Ref No.: BD-CW-SAMCO-ACE-LET-STR-064

Project Name: The Big Business District.

Subject: Notification of claim Due to Delay in Technical Clarifications.

Pump Room Coordination Issues (Crane Clearance)

DIGITAL PHOTO ATTACHED 1

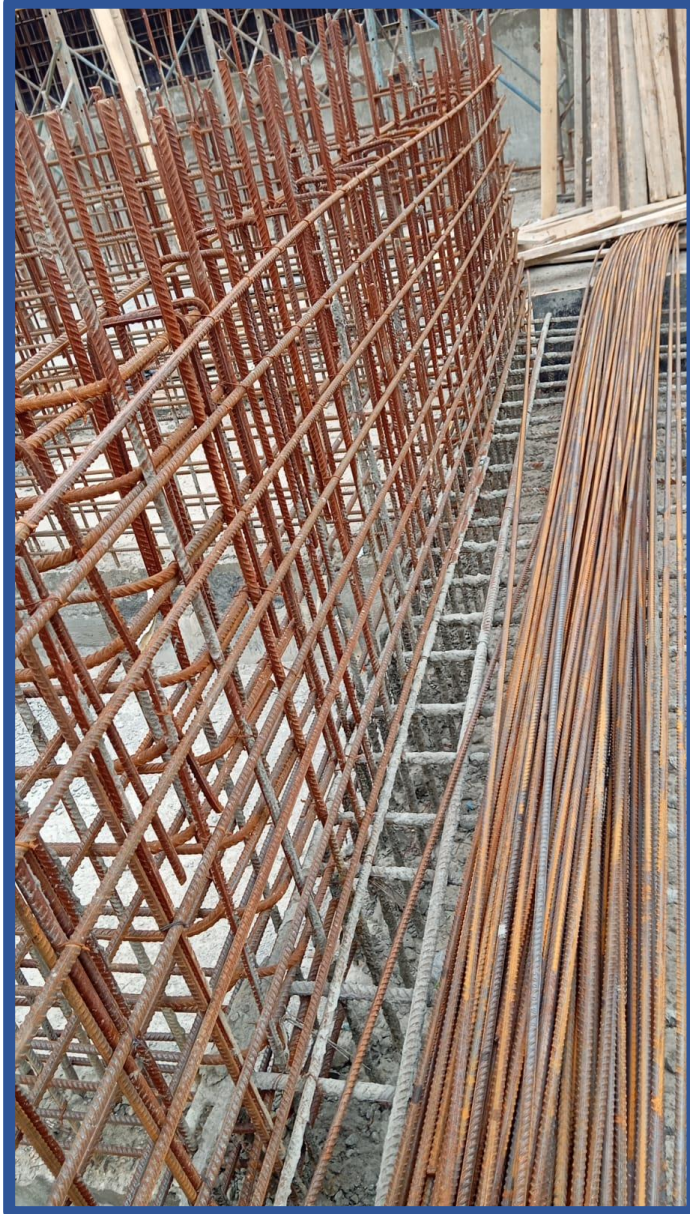
we would like to bring to your attention that no activites of works in the water tank, basement sum pits, and the electrical works in the staircases with in the next two days.

Attached: Photos of the halted works on site for your reference.
